# The Wrexham Gas Fired Generating Station Order

## 14.1: Applicant's comments on submissions made at Examination Deadline 4

**Applicant's comments on submissions made at  
Examination deadline 4**

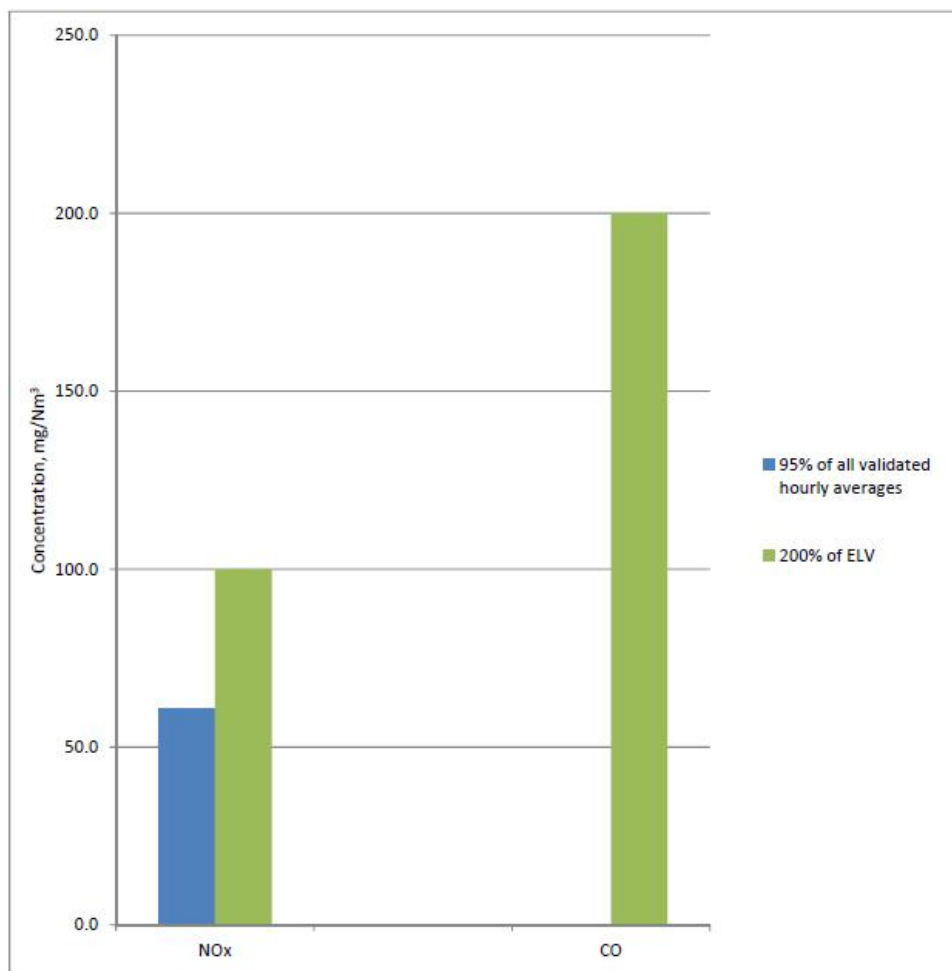
- 2.16. The green bar in the daily and monthly average charts represents what the Applicant has assessed i.e. the ELVs for NOx and CO set in the IED. The blue bar shows how the data provided by Mr Briggs compares with the ELV. Although not a matter for compliance with the IED, the Applicant has also considered the start-up and shutdown information provided by Mr Briggs, shown as the red bar, to address Mr Briggs' specific concerns. If the start-up and shutdown information was included in the assessment for compliance with the ELVs it can be seen that that which was assessed by the Applicant still represent a worse case.

- 2.17. The blue bar shows the value, derived from the data provided by Mr Briggs, that would be used to establish compliance with the IED for the plant, i.e. the 95<sup>th</sup> percentile of all the hourly averages. In the case of the hourly average, the relevant criterion, shown in green, is 200% of the ELV. This was the value used by the Applicant to verify the findings of the air quality assessment for NOx, as agreed with NRW.

- 2.18. The 95<sup>th</sup> percentile for CO is not visible on the graph, as the data provided by Mr Briggs show that once the plant is running normally there are close to zero emissions of this pollutant (in line with efficient combustion).
